North Eastern Regional Power Committee

84th Protection Coordination Sub-Committee Meeting

Date: 09/10/2025 (Thursday)

Venue: Bongaigaon Thermal Power Plant, NTPC

C.4 Grid Disturbance in Mynkre area and Leshka HEP of Meghalaya Power System on 1st June'25:

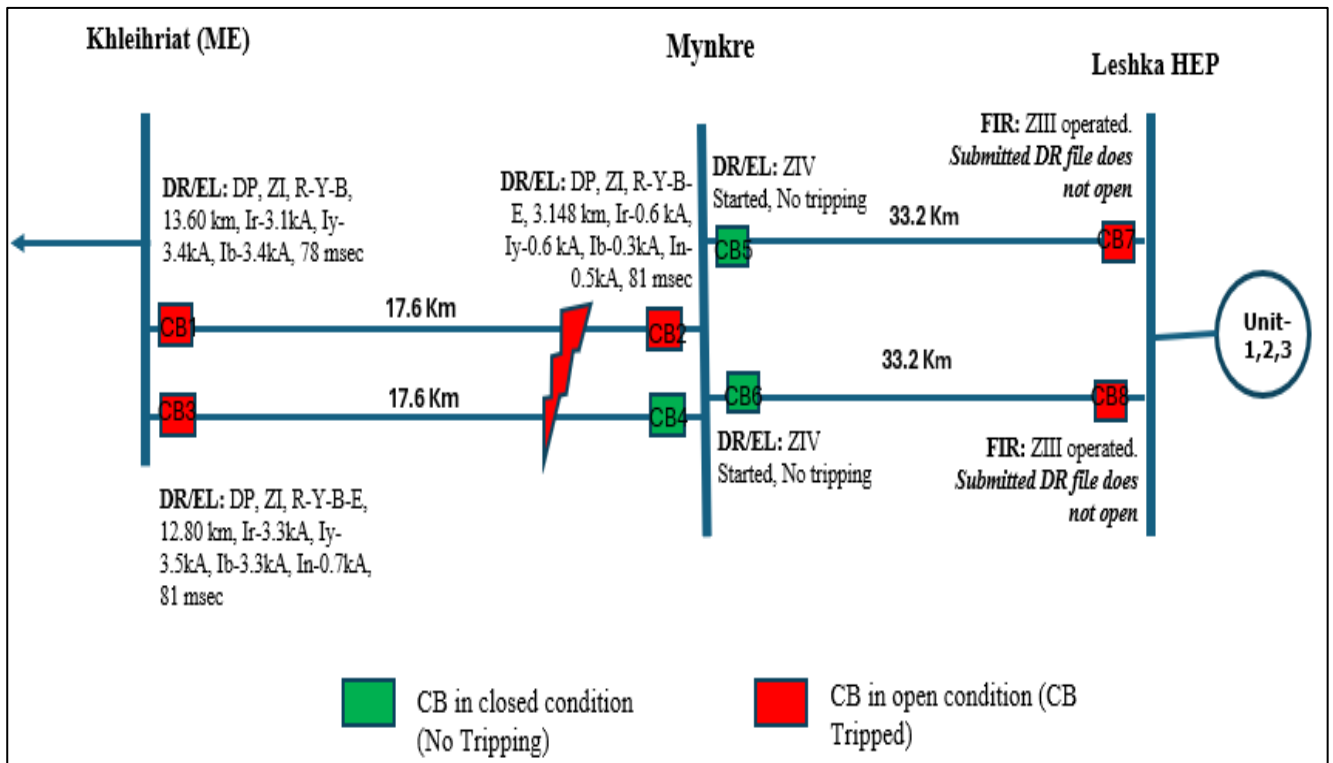
As per DR analysis of 132 kV Mynkre (ME)-Khliehriat(ME) 1 line, solid R-Y-B fault (Ir-3.1 kA, Iy-3.4 kA, Ib-3.4 kA) initiated at 05:37:08.630 Hrs which was cleared within 81 msec on operation of DP, ZI.

C.6 (Agenda B8, 82nd PCC) Frequent tripping of 132 kV Sanis-Wokha Line during July'25:

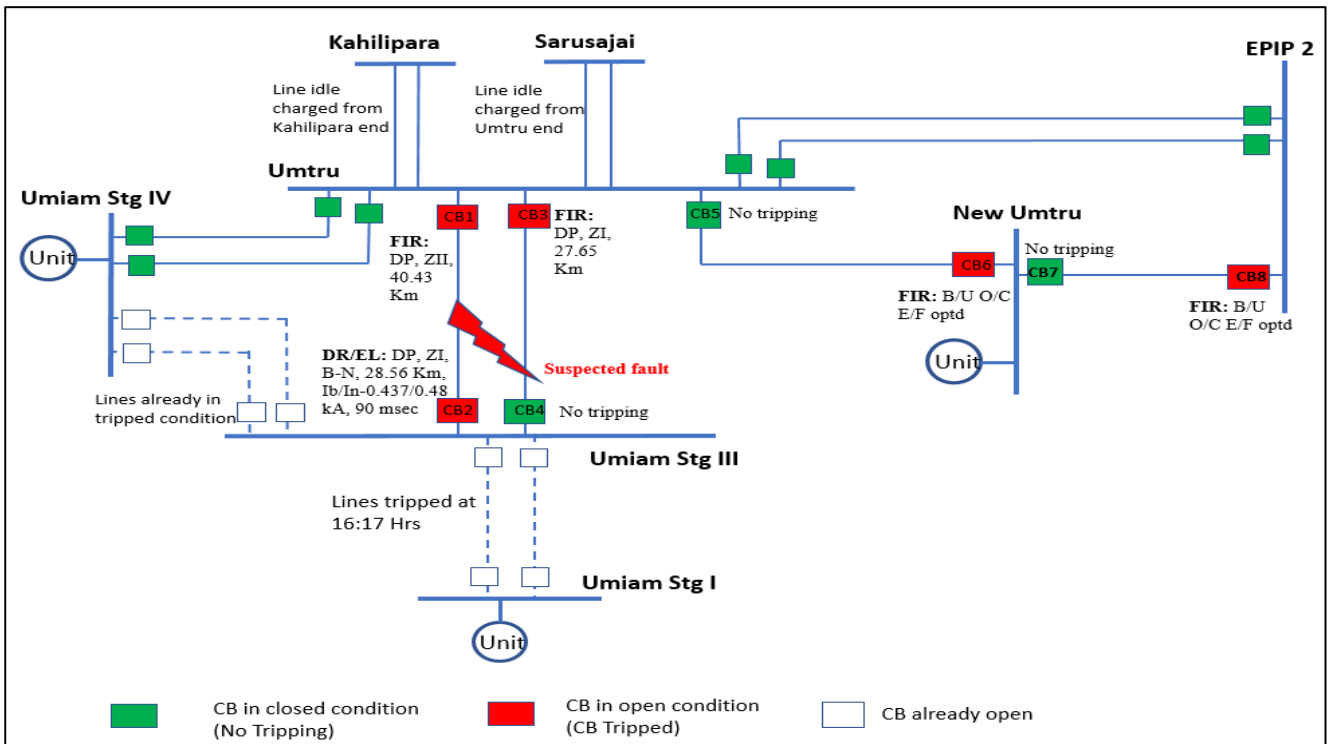
132 kV Sanis-Wokha Line tripped 9 number of times during July'25 which is a matter of concern.

In 82nd PCCM, forum noted that most of the tripping were spurious in nature and some tripping may be due to settings issue. Forum urged DoP, Nagaland to analyze the root cause of such trippings and provide a report to NERPC and NERLDC.

C.8 (Agenda B11, 81st PCC) Grid Disturbance in Dharmanagar area of Tripura Power System and Dullavchera area of Assam Power System on 10th June'25:

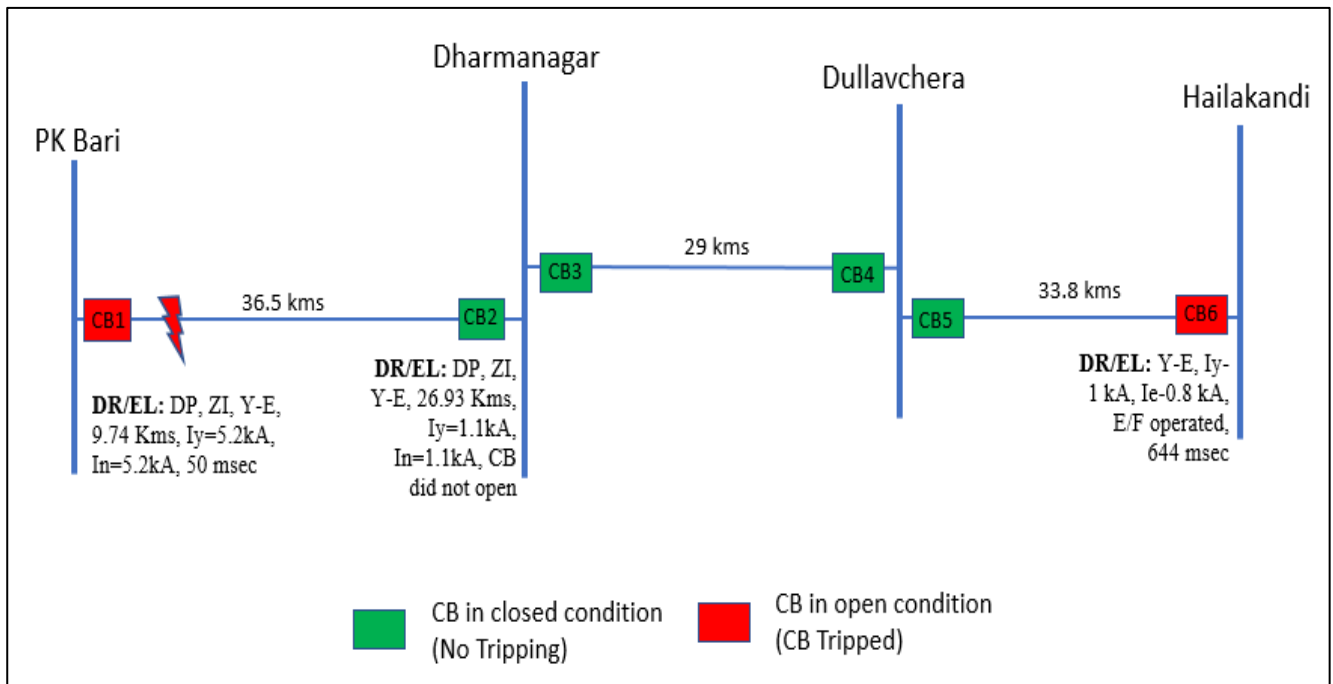
As per DR analysis, Y-N fault (I_b-5.2 kA, I_n-5.2 kA) initiated at 18:40:57.118 Hrs which was cleared within 50 msec from PK Bari on operation of DP, ZI. At Dharmanagar end, ZI trip command issued at 18:25:30.360 Hrs. However, CB did not open at Dharmanagar due to which fault was continuously feeding from Dullavchhera & Hailakandi end. Fault cleared by tripping of healthy 132 kV Hailakandi-Dullavchhera line within 644 msec from Hailakandi end on operation of E/F (DT send).

Event 1:

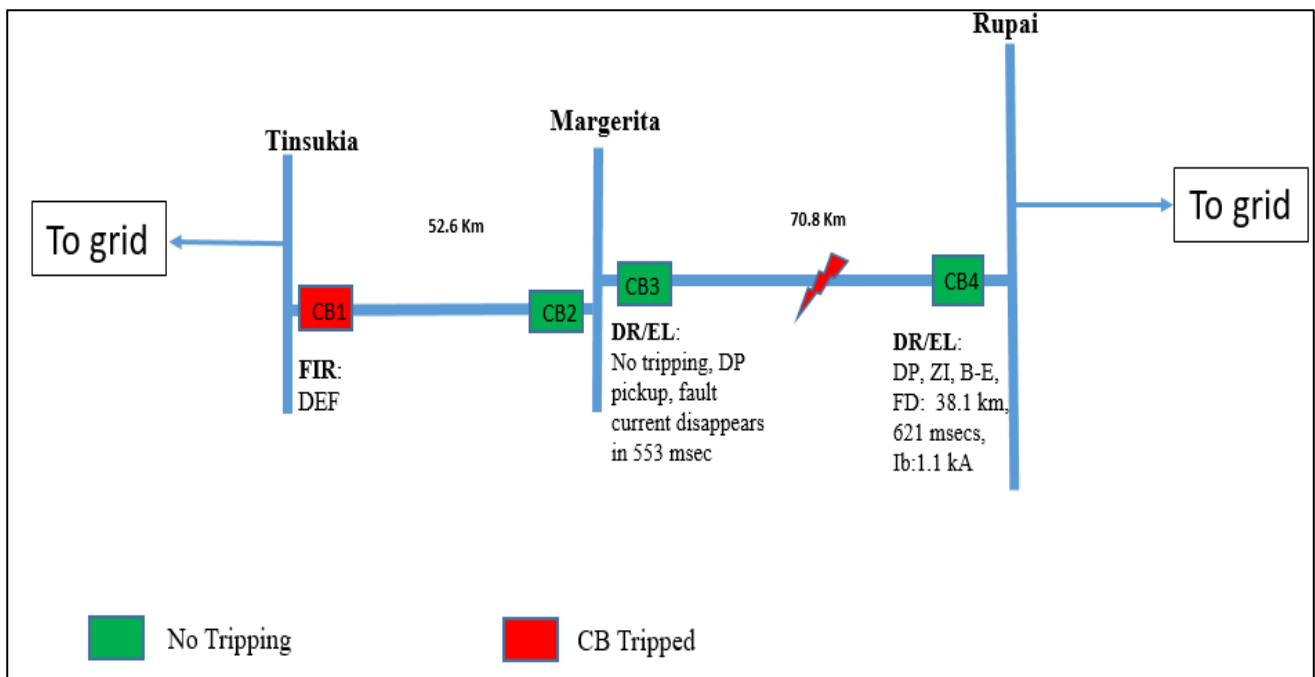
As per DR analysis, at 10:50:26.946 Hrs, high resistive B-E fault (Ib-1.1 kA, Vbe-51 kV) appears in 132 kV Rupai-Margherita line at a distance of 38.1 Km which was cleared from Rupai end within 621 msec on operation of DP, ZI. No tripping observed at Margherita end (DP pickup, fault current disappears within 553 msec).

- Protection system at Margherita end for 132 kV Rupai Line failed to isolate the fault leading to clearing of fault by tripping of healthy 132 kV Margherita-Tinsukia line from remote end.
- Time drift of 3 min observed at Rupai end for 132 kV Margherita Line.

Event 2:

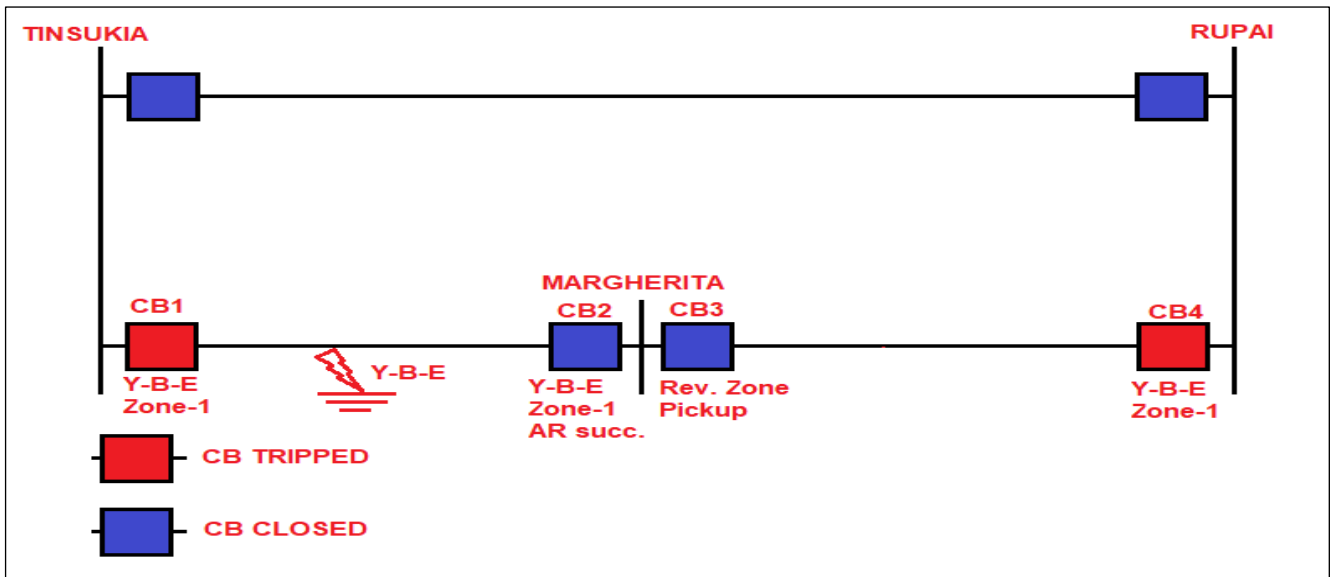
As per DR analysis, Y-B-E fault in 132 kV Tinsukia – Margherita line cleared from Tinsukia and Margherita end in 90 msecs on operation of DP, ZI. Margherita end (CB2) successfully auto-reclosed.

Event 2: Forum noted that zone 1 at Rupai for 132 kV Margherita line is overreaching and requested AEGCL to revise the reach of Zone1 protection. AEGCL informed S/D will be taken for testing of relay.

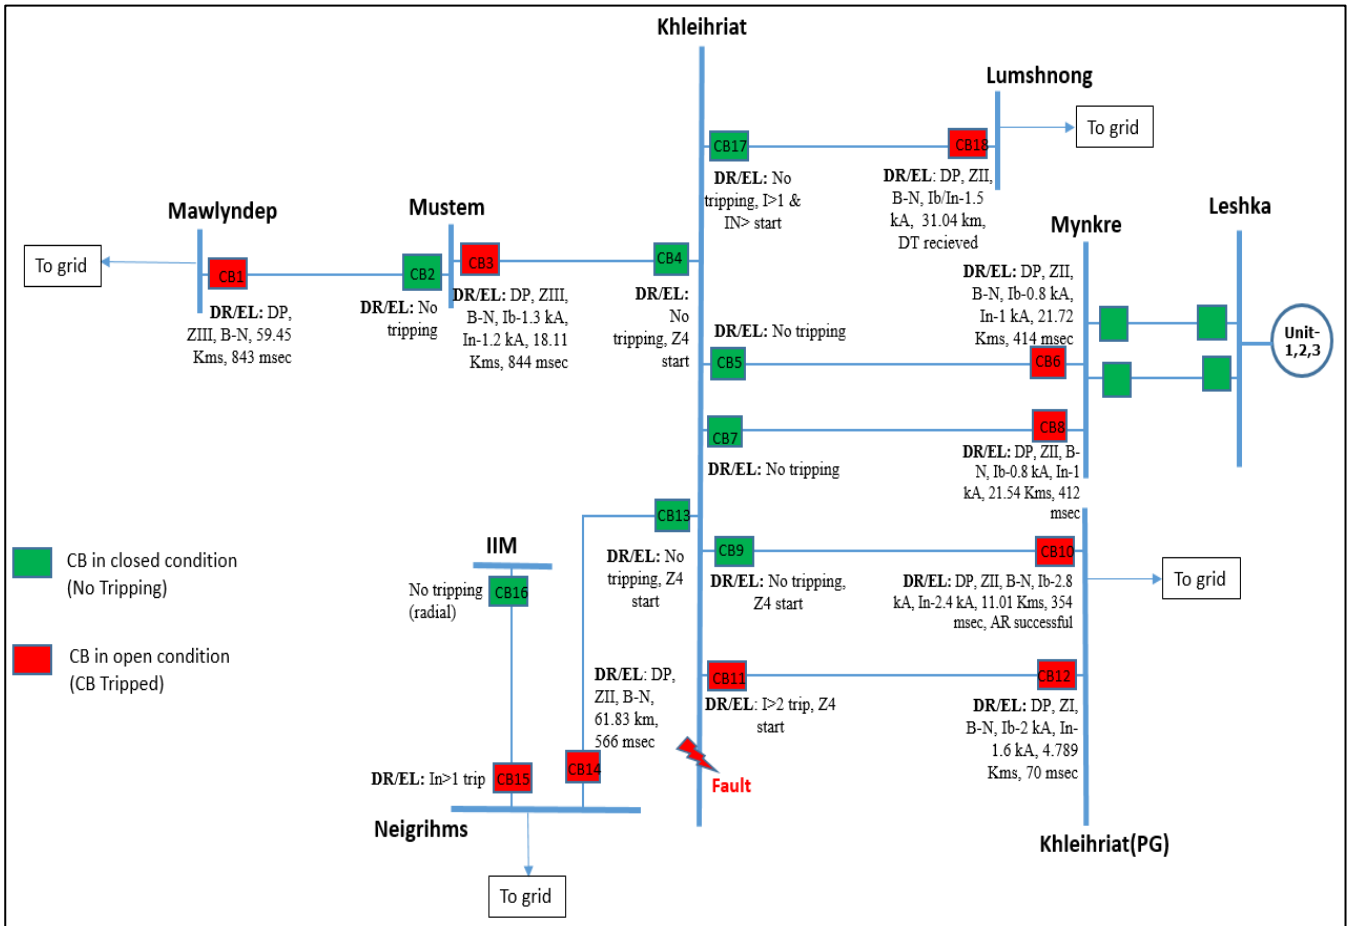
- Tripping of 132 kV Mustem-Khleihriat line on Z3 from Mustem end is inferred unwanted. Z3 reach setting needs to be reviewed and revised as per NER protection philosophy.

| 4 | Tripping of 132 kV Mustem-Khleihriat line on Z3 from Mustem end | LFL of the feeder was carried out to ascertain the exact line length and line length indicated was 16.9 Km. Earlier setting was kept as per 12.69 Km. The setting of 132 kV Mustem-Khleihriat line has been revised as per new line length of 16.9 Km on 25th June'25. |
